1st Further Information

Temporary Shop and Services with Ancillary Facilities for a Period of 5 Years in "Recreation" Zone, Lot 343 in D.D. 104, Ngau Tam Mei, Yuen Long, New Territories

(S.16 Planning Application No. A/YL-NTM/485)

FSIs PROPOSAL

APPENDIX II 001

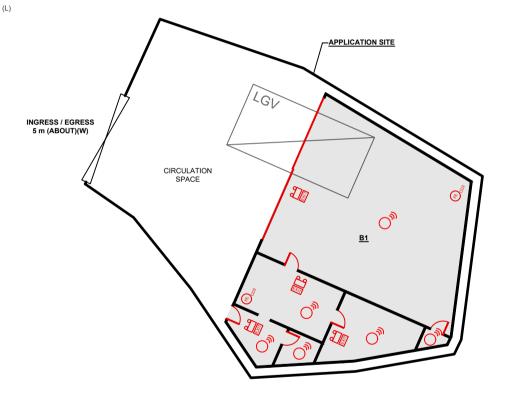
- (1) Please note the following comments on the Fire Service Installations (FSIs) proposal submitted:
 - (i) For enclosed structure with gross floor area not exceeding 230 m², only fire extinguisher and Stand-alone Fire Detector shall be provided;
 - (ii) In relation to i. above, where two or more Stand-alone Fire Detectors are installed in an enclosed structure, all stand-alone detectors shall interconnected (either wired or wirelessly) such that when one of the stand-alone fire detector is triggered, connected Stand-alone Fire Detectors shall sound an alarm simultaneously;
 - (iii) The Stand-alone Fire Detector shall be provided in accordance with the "Standalone Fire Detector General Guidelines on Purchase, Installation & Maintenance [Sep 2021]"; and
 - (iv) Emergency lighting, directional and exit signs are considered as selfupgrade and not a mandatory requirement by this Department.

Noted. The revised FSIs proposal is enclosed at **Appendix II** for your consideration please.
